DESIG	B	DRAWN BY	DART AEROSPACI HAWKESBURY, ONTARIO, CA	
CHEC	KED	APPROVED	DRAWING NO.	REV. A
(_	At-	DSI 9377	SHEET 1 OF 2
DATE			TITLE	SCALE
07.05.24			STRUT MODIFICATION KIT	NTS
Α		07.05.24	NEW ISSUE

DART SERVICE INSTRUCTION

TO AMEND INSTALLATION INSTRUCTIONS IIN-D130-701 REV. B REF. CANADIAN STC: SH94-14 REF. FAA STC: SR00213NY

DETAIL A: STRUT INSTALLATION

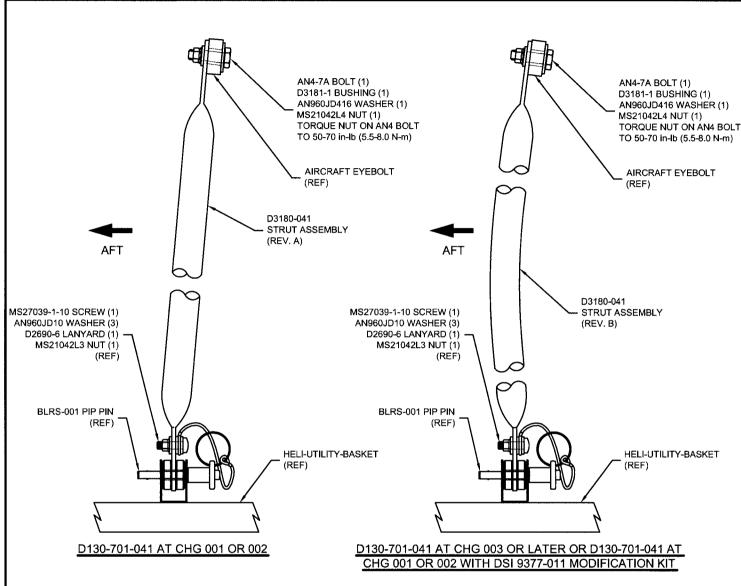
TO MAKE THE D130-701-041 HELI-UTILITY-BASKET COMPATIBLE WITH THE EUROCOPTER CANADA CARGO PODS, THE D3180-041 STRUT ASSEMBLY HAS BEEN MODIFIED AS SHOWN IN DETAIL A IN D130-701-041 AT CHG 003 OR LATER. TO MAKE THE DART D130-701-041 HELI-UTILITY-BASKET AT EXISTING CHG 002 OR EARLIER COMPATIBLE WITH THE CARGO PODS. IT IS NECESSARY TO REPLACE THE D3180-041 STRUT ASSEMBLY WITH THE DSI 9377-011 STRUT MODIFICATION KIT. THIS KIT INCLUDES A REPLACEMENT STRUT AND THE HARDWARE REQUIRED TO INSTALL IT.
